SAN ONOFRE'S STEAM GENERATOR FAILURES COULD HAVE BEEN PREVENTED

May 14, 2012

REPORT COMMISSIONED BY FRIENDS OF THE EARTH

Figure 2: Eggcrate Tube Support Plate - Designed To Keep Tubes From Rattling

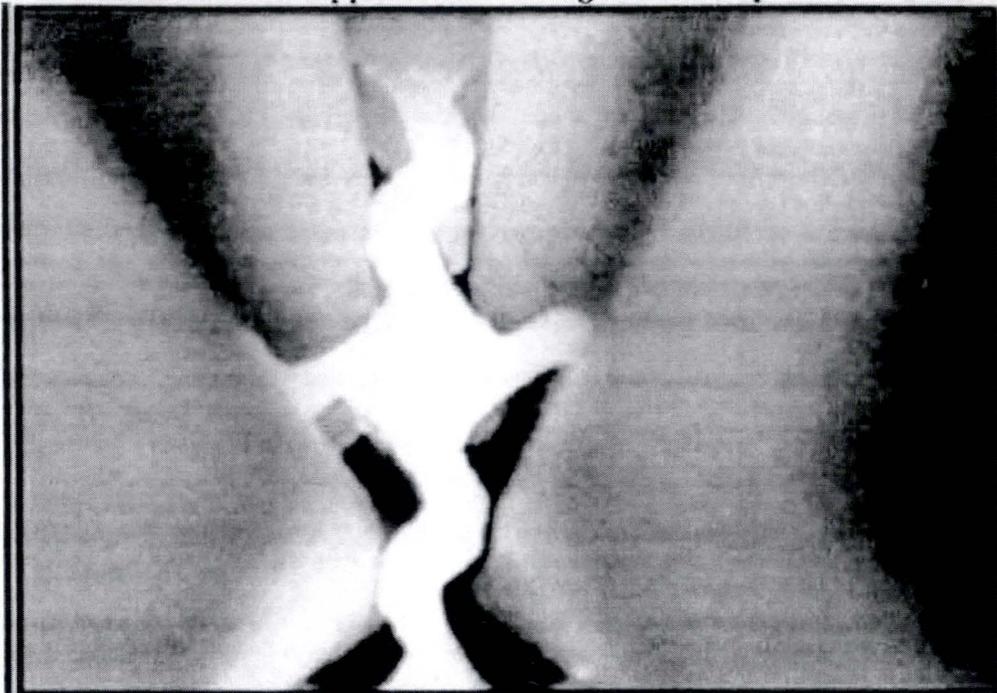
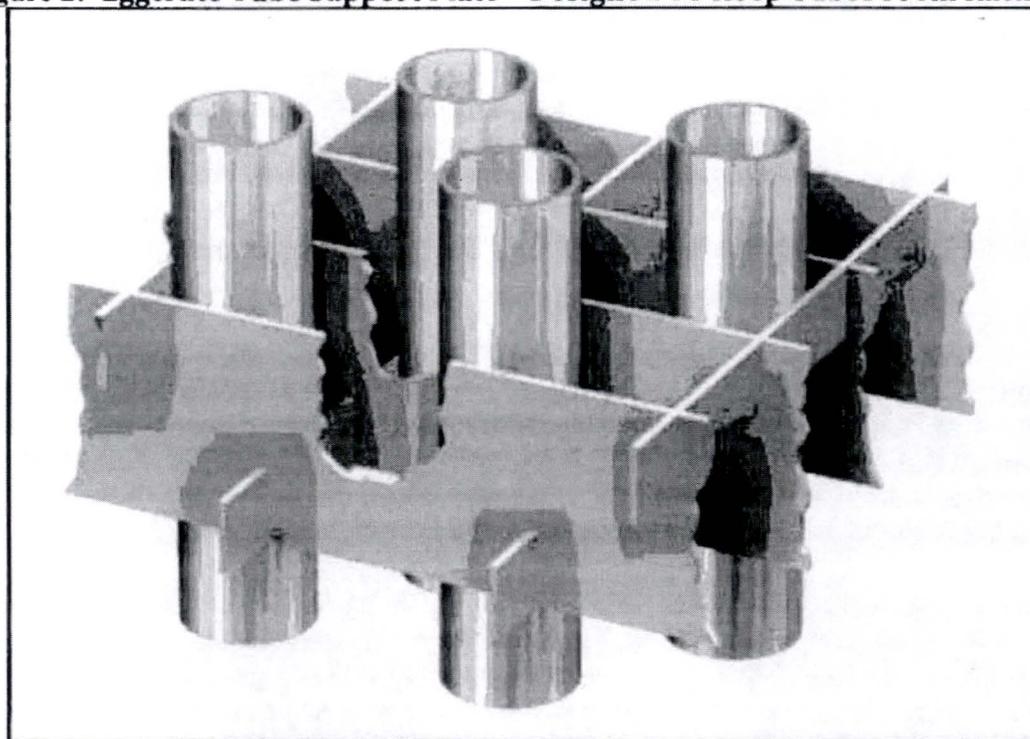
— TRUE —

FLOW
BLOCKAGE IS LESS FOR
EGGCRATE
DESIGN
